## **A63 Castle Street Improvement, Hull**

### **DCO Documents Errata**

- 1.1.1 This Errata lists amendments to the Development Consent Order (DCO) documents which formed the A63 Castle Street Improvement, Hull application submitted to the Planning Inspectorate in September 2018. The Errata focuses upon corrections as opposed to typographical errors. Documents are presented in the order with which they were submitted for DCO.

Volume Title: **VOLUME 2 FIGURE 2.5.4 THE SCHEME PROPOSALS - SHEET 3 OF 8**

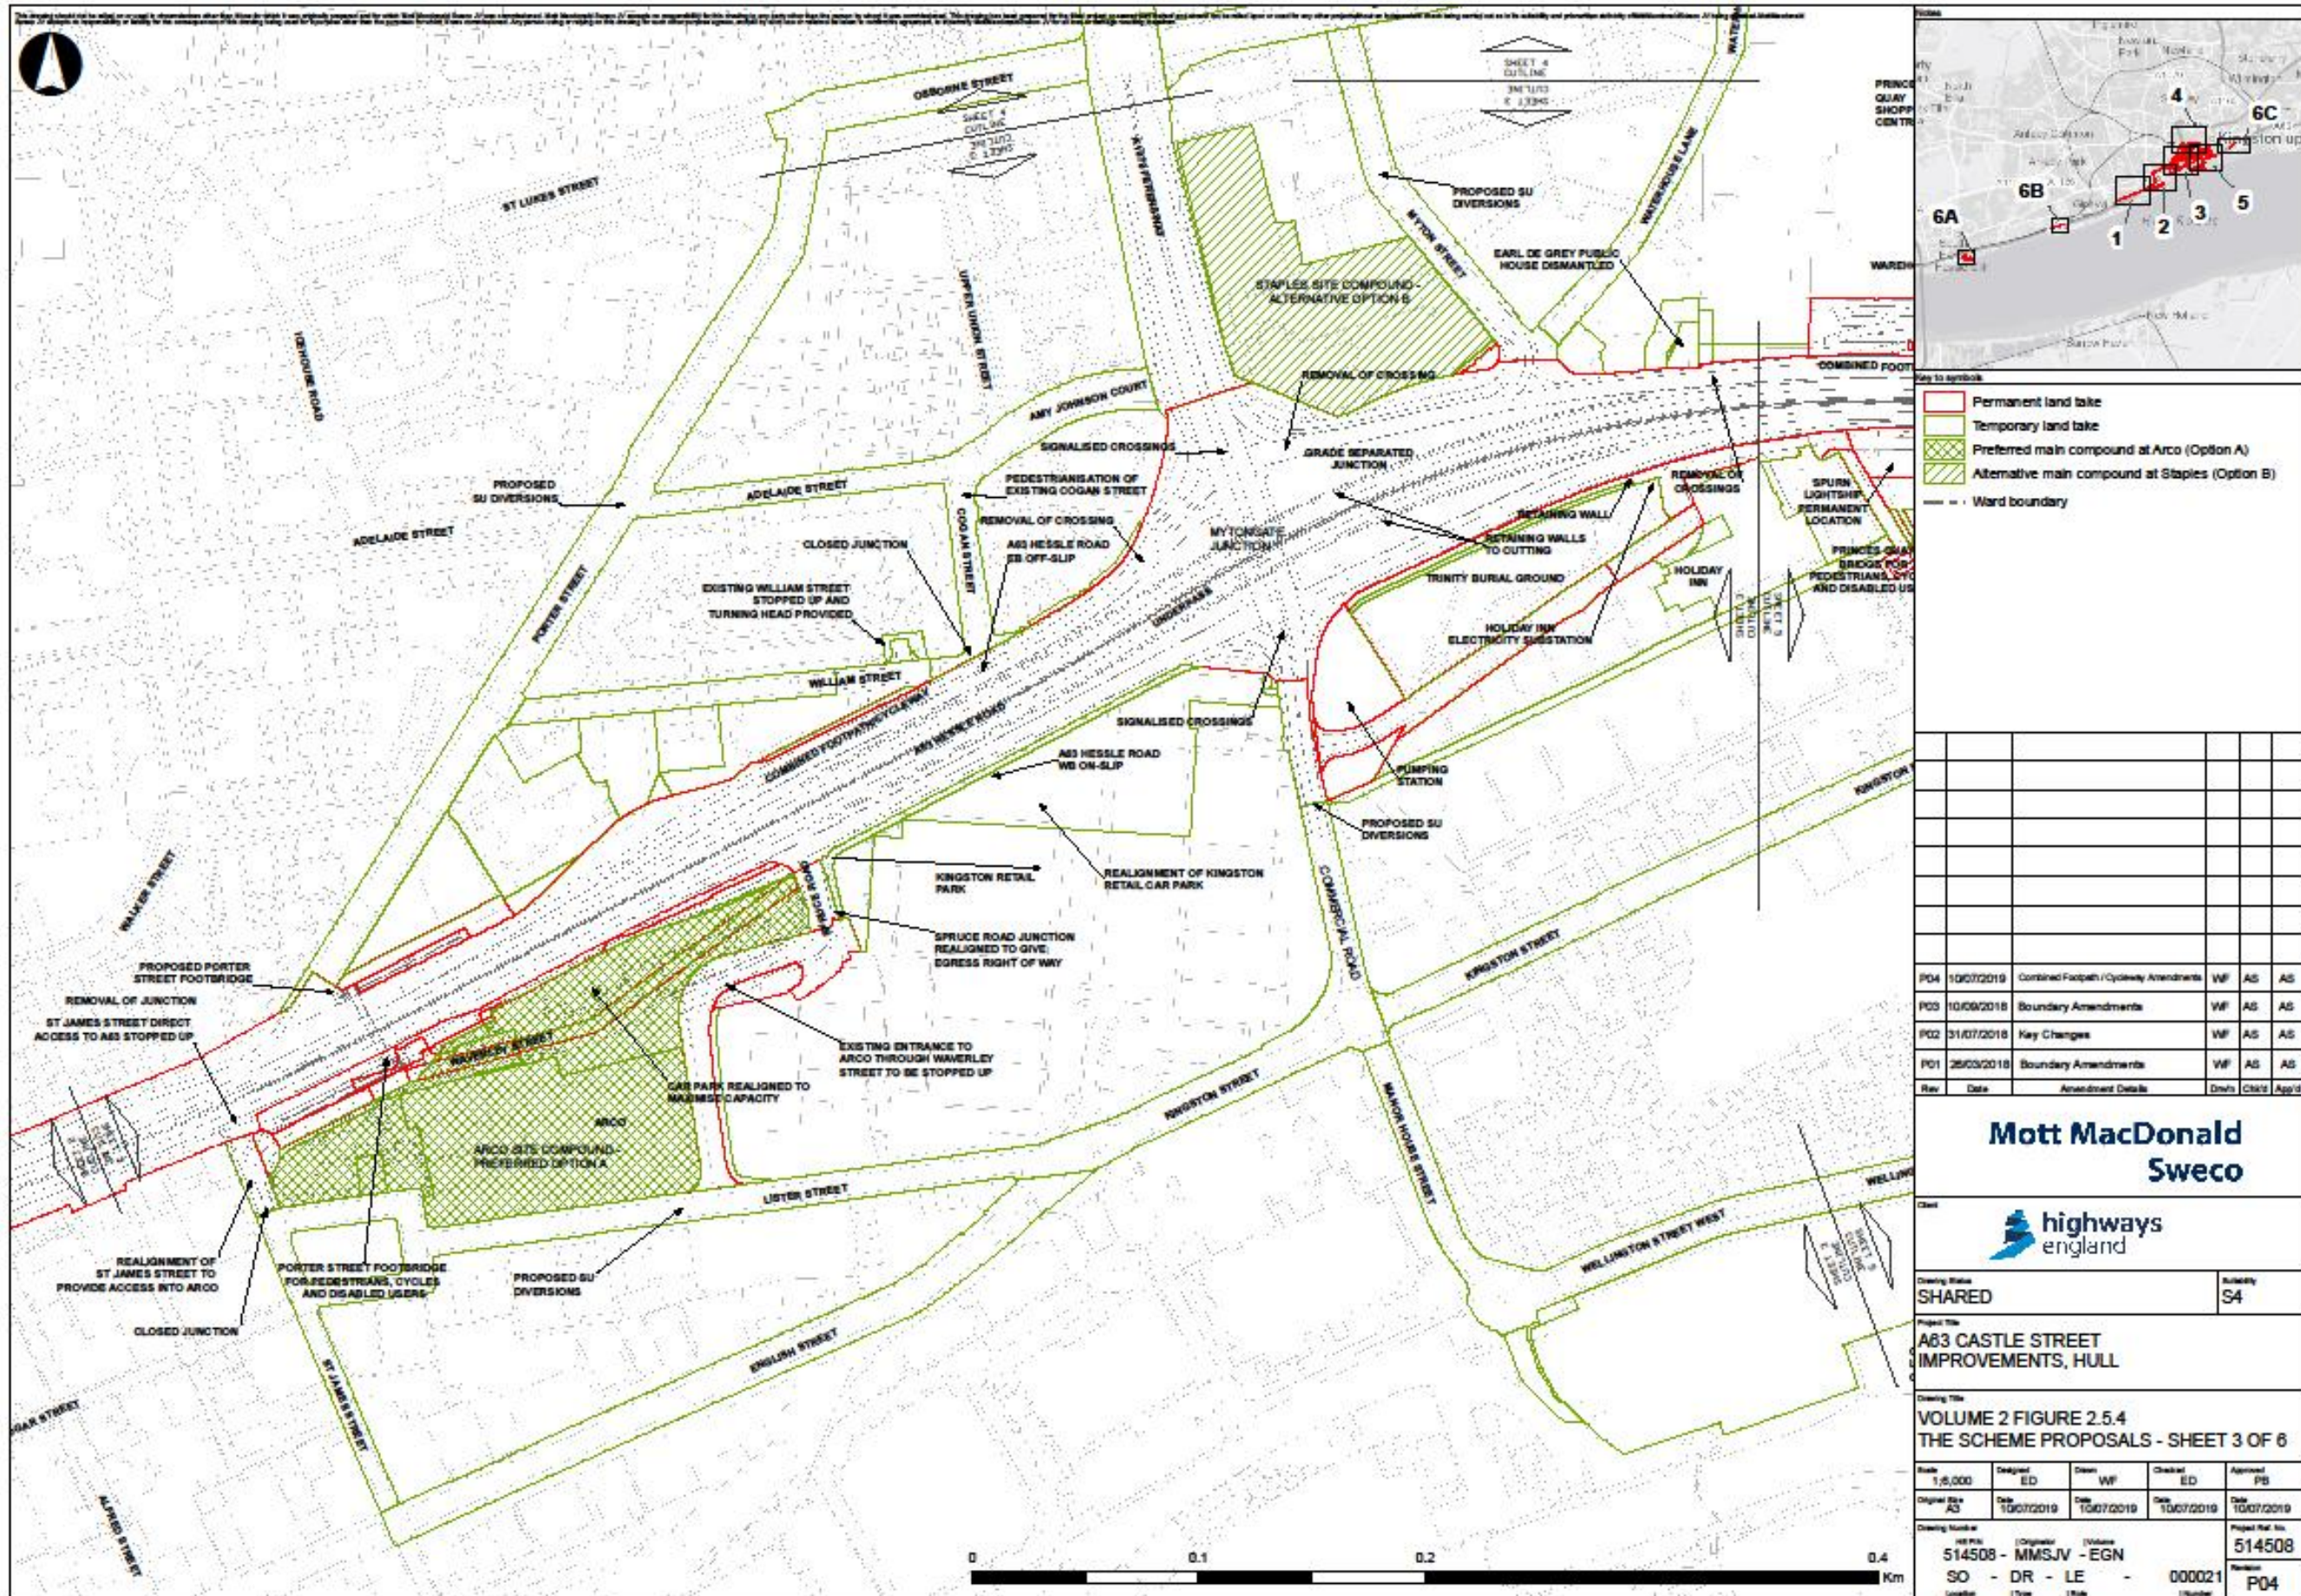
3.1.1 Replace ES Volume 2 Figure 2.5.4 The Scheme Proposals – Sheet 3 of 6 and Figure 2.5.6 The Scheme Proposals – Sheet 5 of 6 (APP-025) with the new Figures 2.5.4 and 2.5.6 below. Changes are as follows:

- Locations of the combined footpath & cycleway have been clarified.

Drawing Title  
**NON-STATUTORY DESIGNATED SITES  
VOLUME 2 FIGURE 10.2**

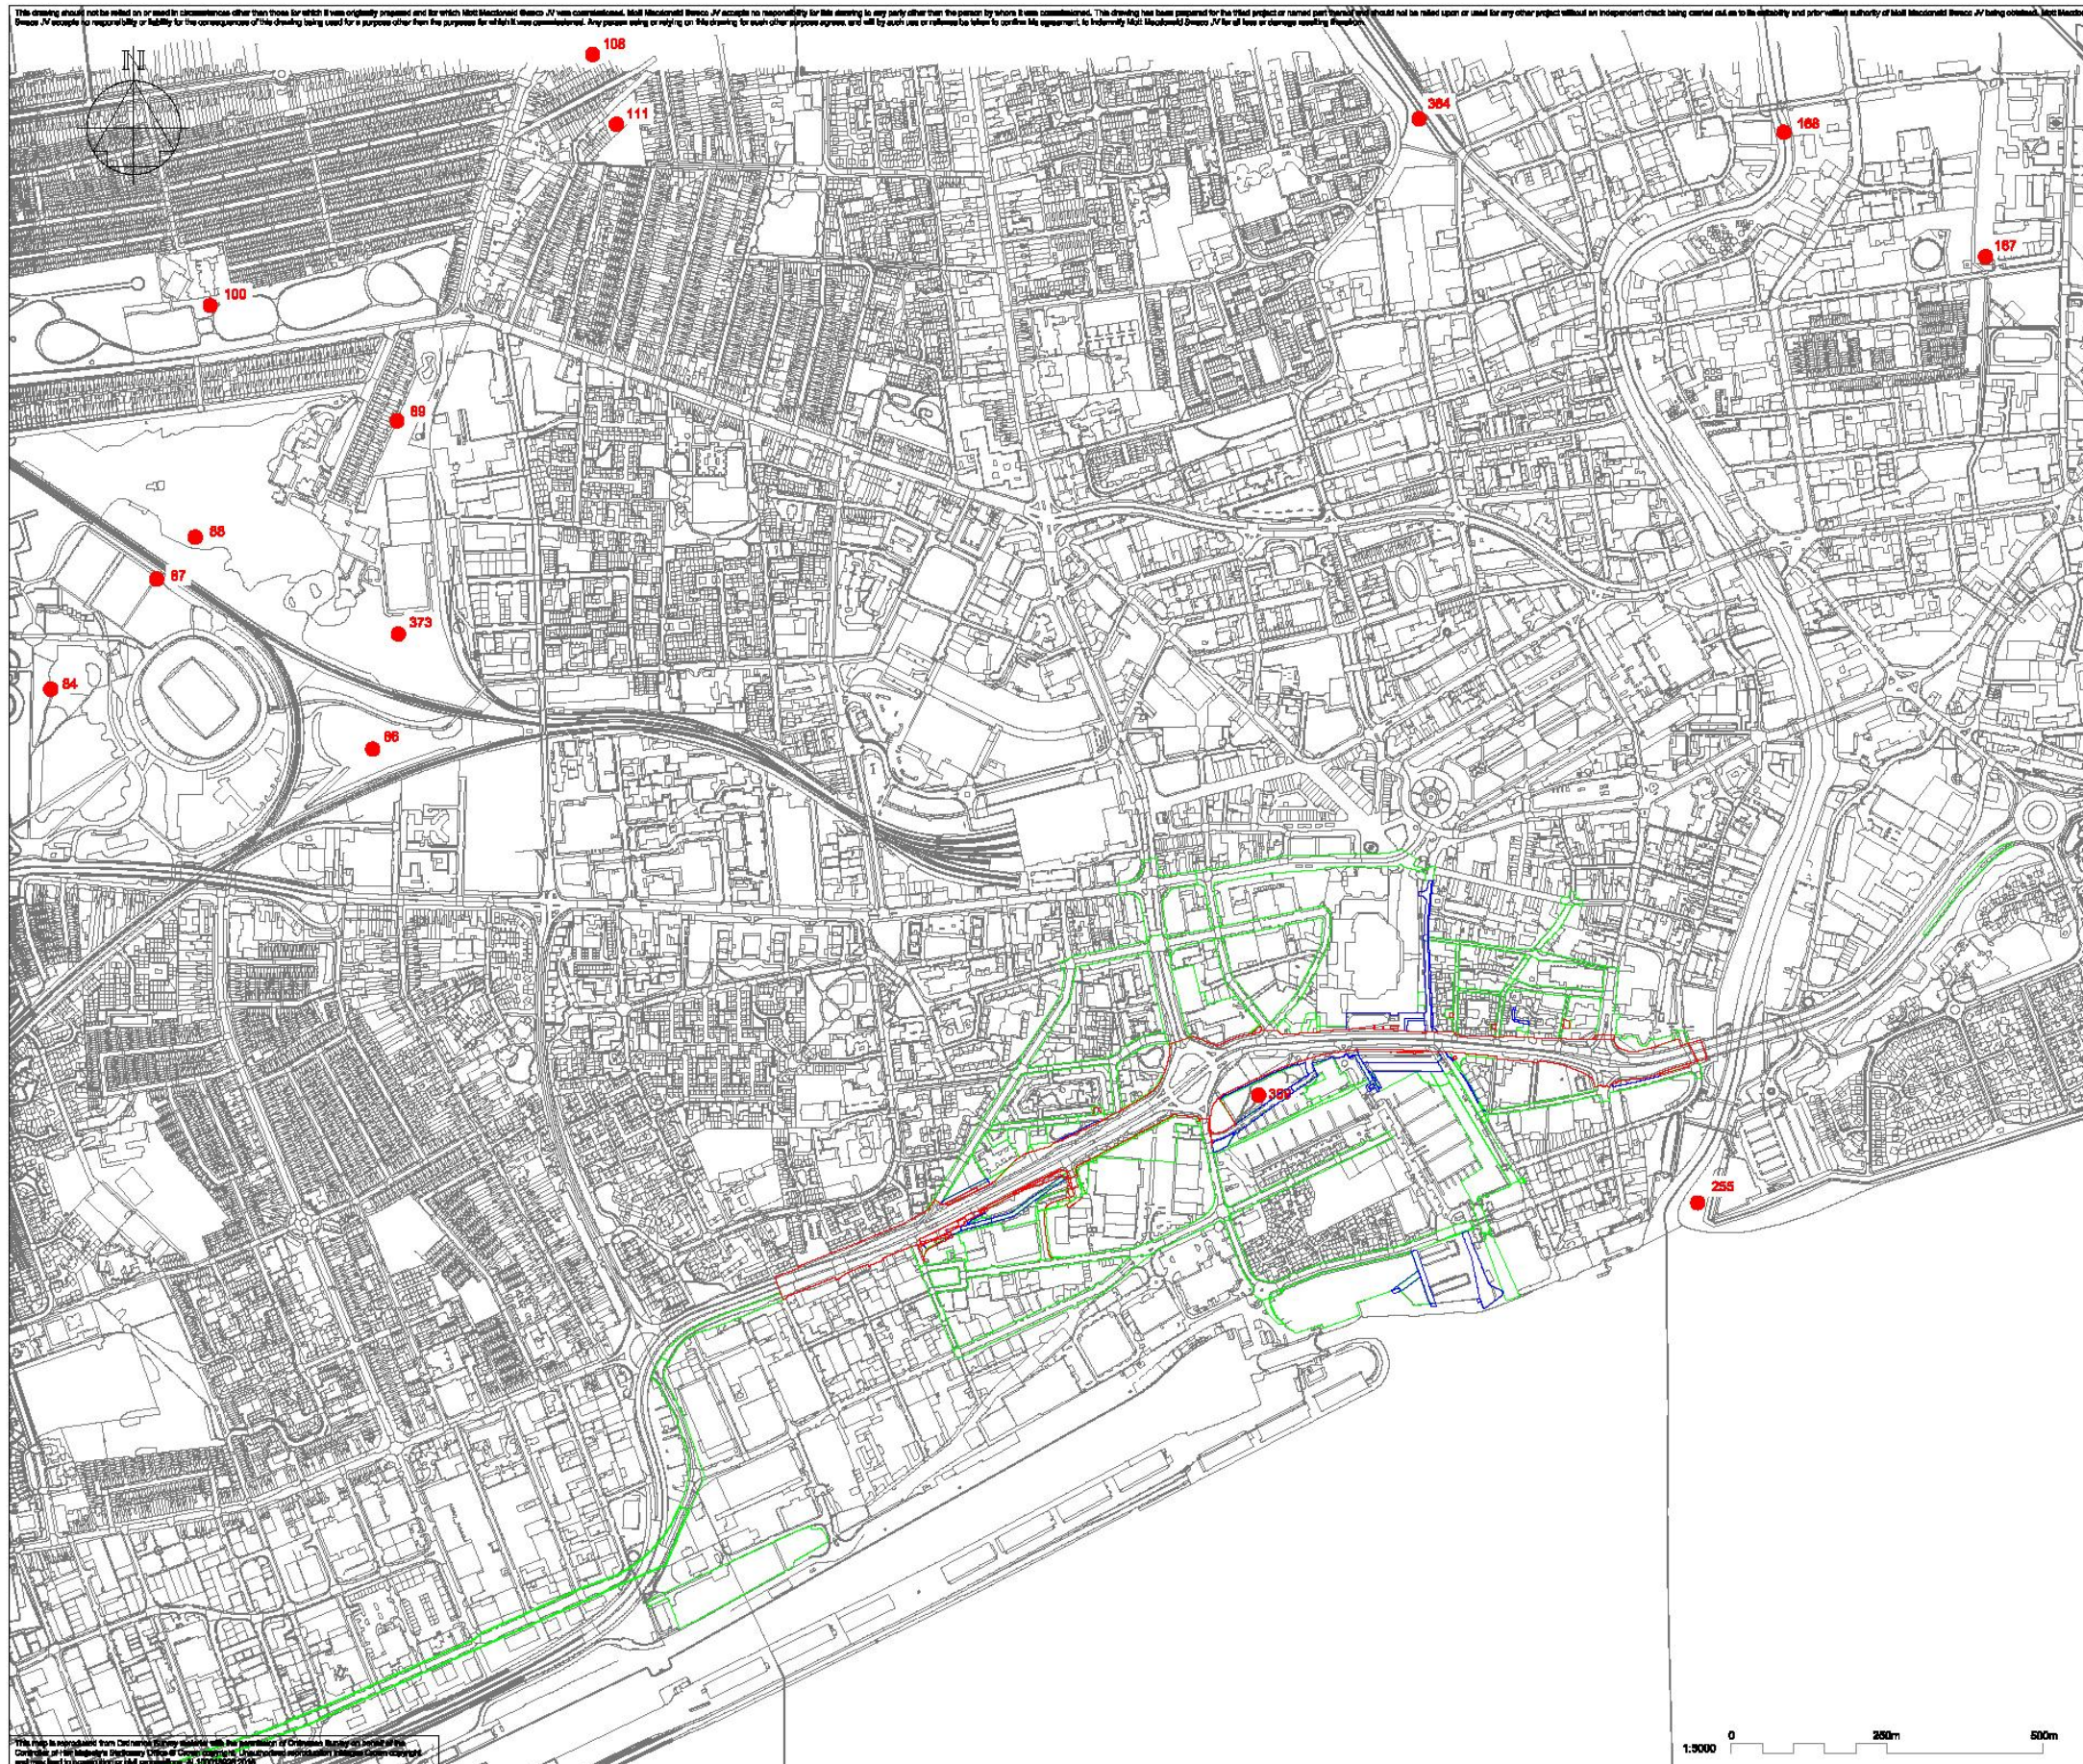
4.1.1 Replace ES Volume 2 Figure 10.2 Non-statutory designated sites (APP-036) with the new Figure 10.2 Non-statutory designated sites as below. Changes are as follows:

- The key has been replaced.
- Sammy's Point Site of Nature Conservation Interest (SNCI) has been added to Figure 10.2 as the mudflats are 250m from the Site boundary.

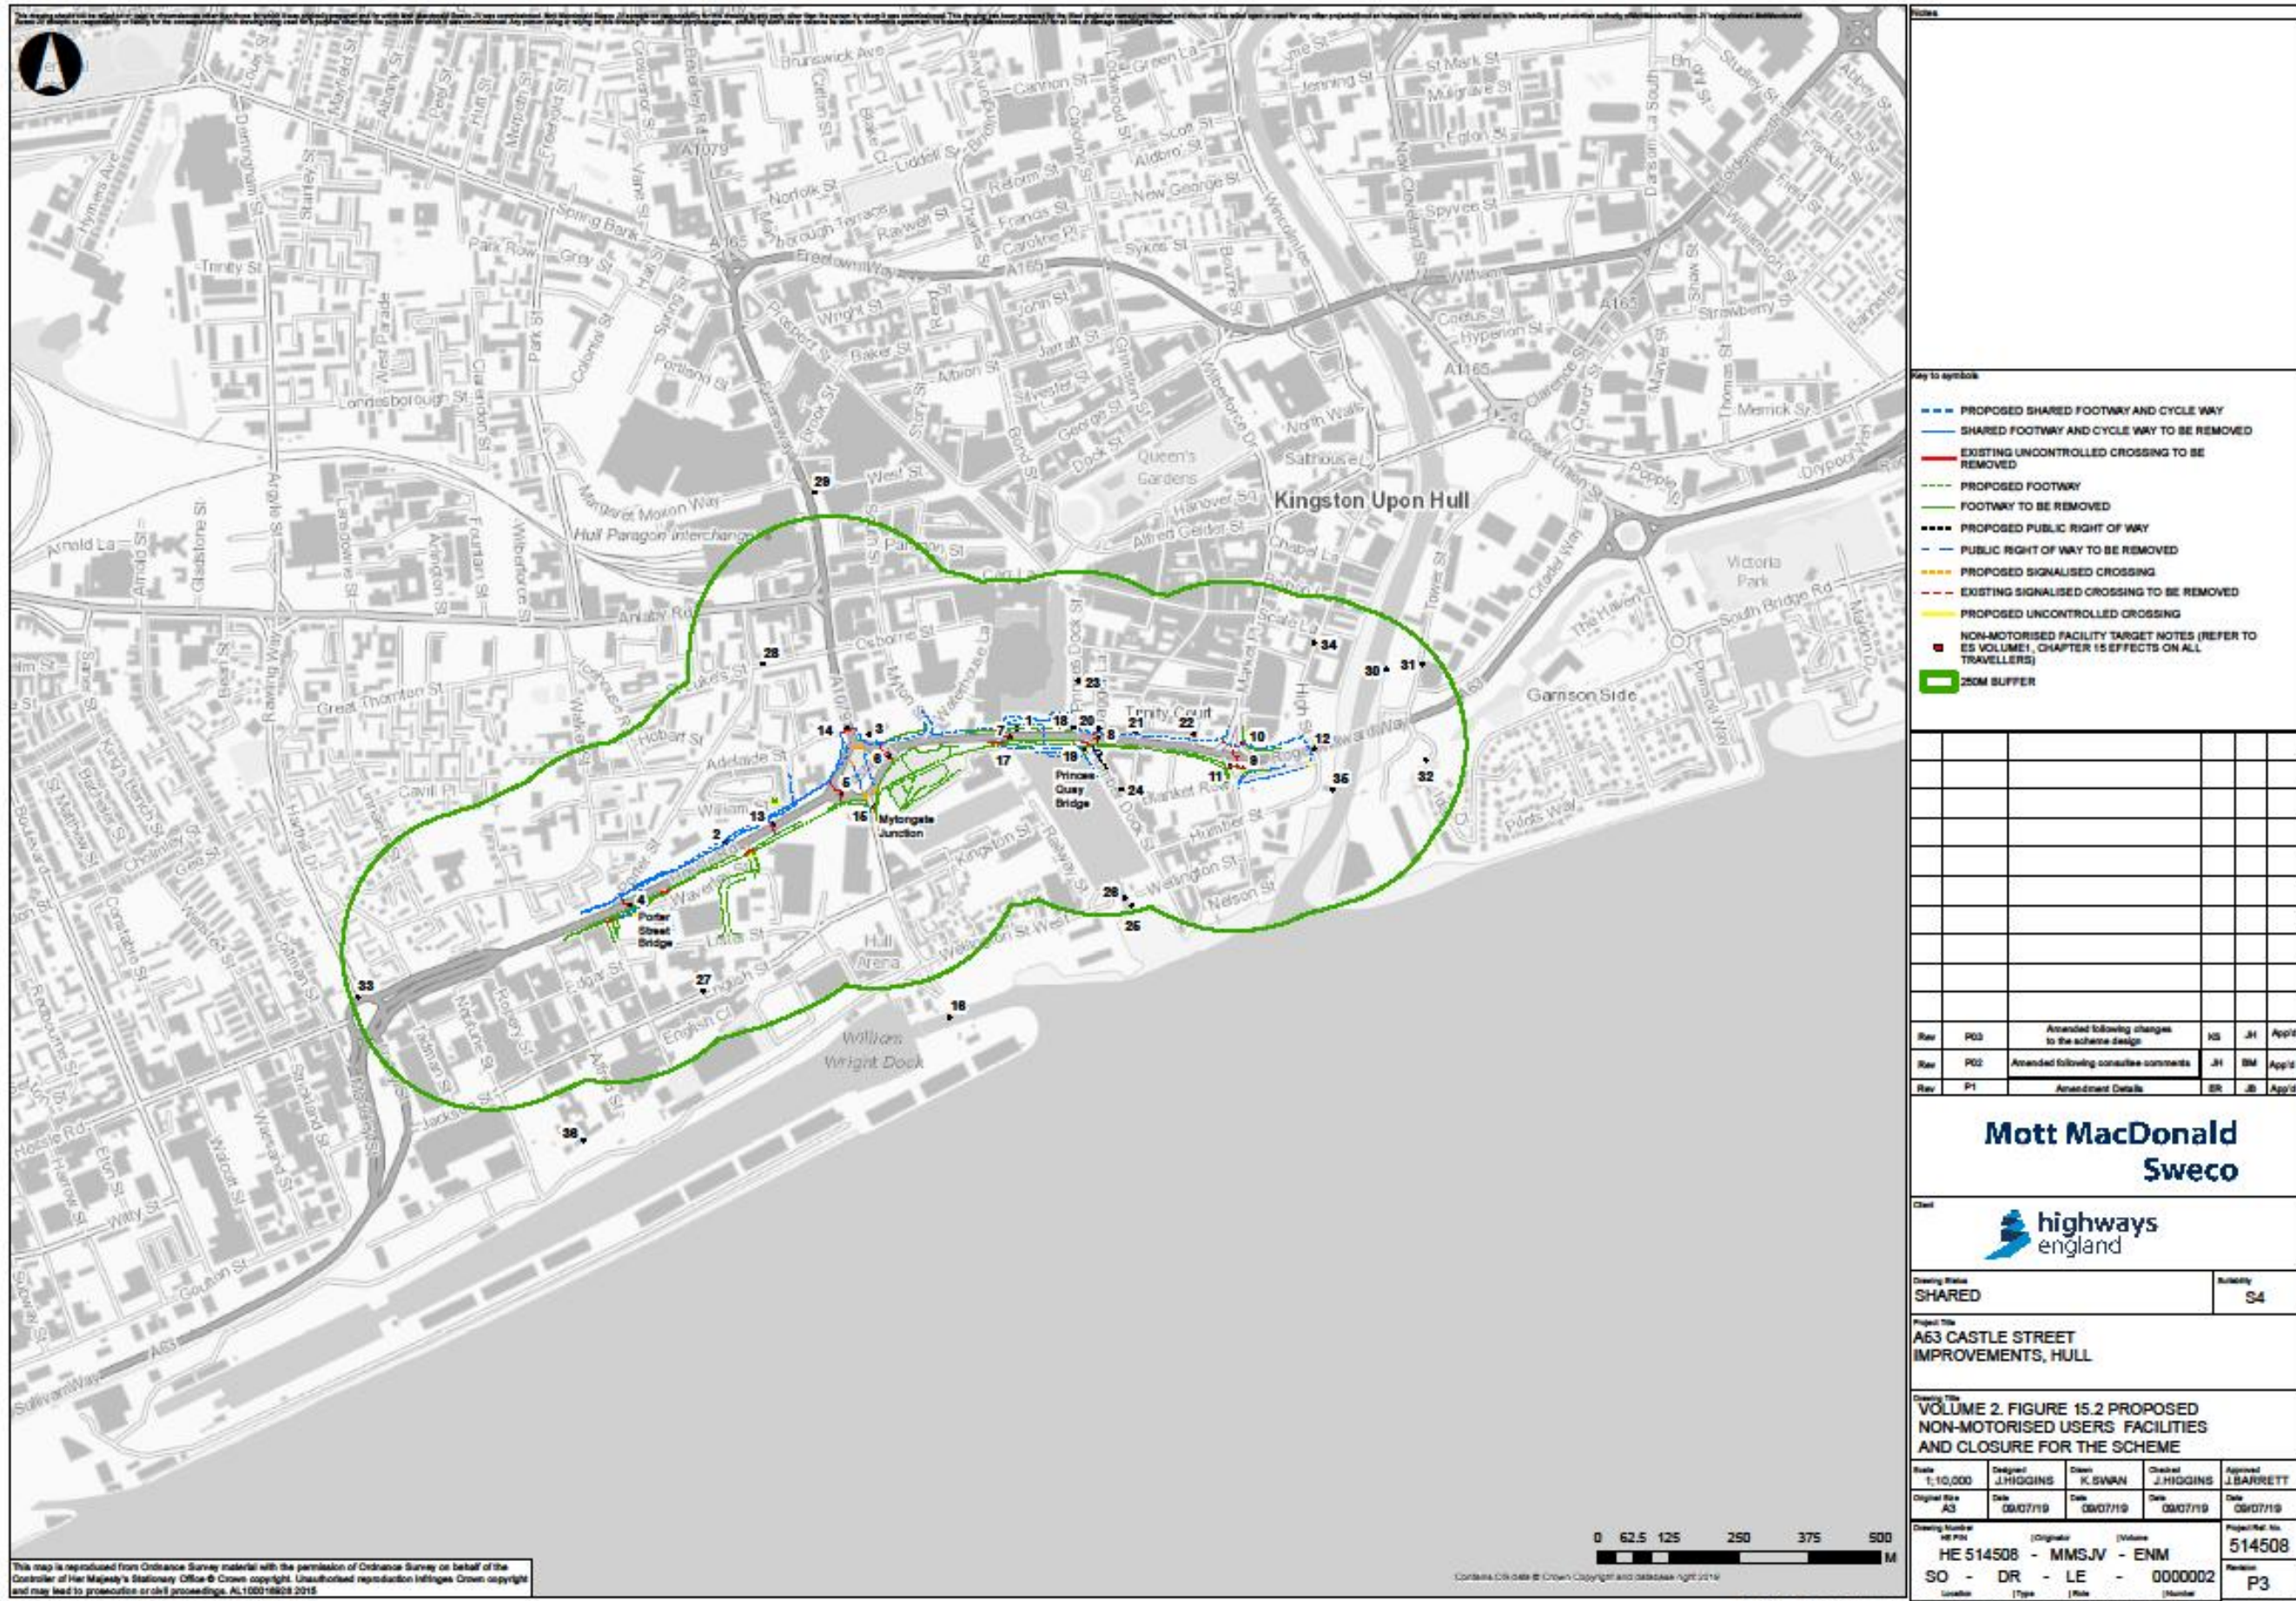
5.1.1 Replace ES Volume 2 Figure 15.2 Proposed non-motorised users facilities and closure for the Scheme (APP-040) with the new Figure 15.2 as below. Changes are as follows:

- Locations of the combined footpath & cycleway have been clarified.
